H-TYPE RELAYAIR® VALVES

Exhaust Valve Modification

APRIL, 1998

EXHAUST VALVE ASSEMBLY, PC. NO. 651104

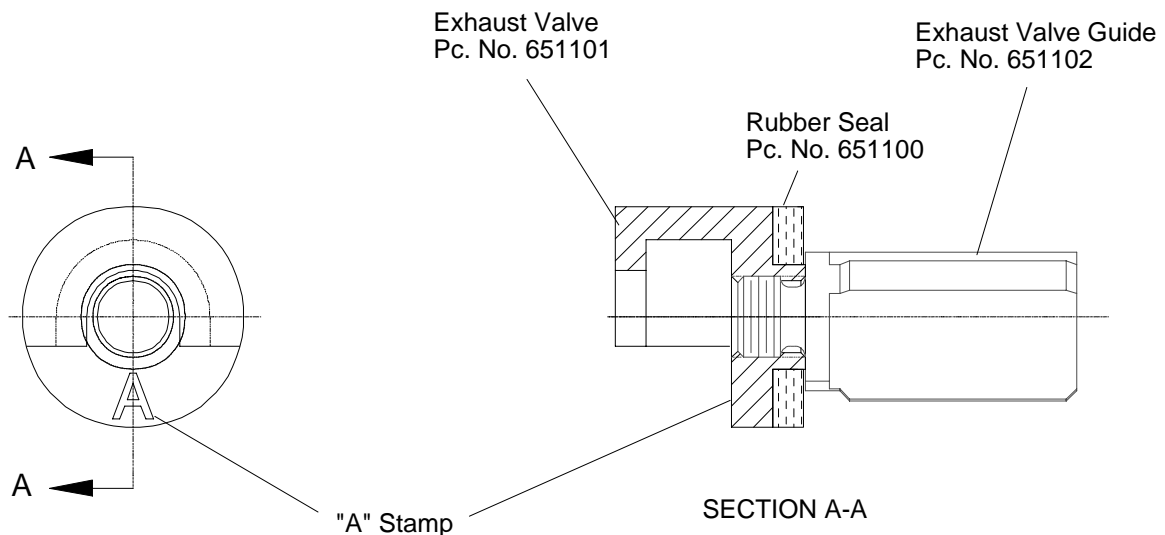
The exhaust valve component of the **H-Type Relayair Valve Exhaust Valve Assembly, Pc. No. 651104**, has been updated to control compression of the rubber seal. During assembly, the rubber seal is compressed between the exhaust valve guide and the exhaust valve as the brass components are threaded together. To control the compression of the rubber seal, adjustments to the exhaust valve dimensions have been implemented.

The configuration control level of the exhaust valve, pc. 651101, has been raised to "A" to reflect the dimensional changes. The "A" is stamped on the underside of the exhaust valve, as shown in the figure below. The exhaust valve assembly should be replaced with the *NEW DESIGN* during the first removal and cleaning of the H-Type Relayair Valve.
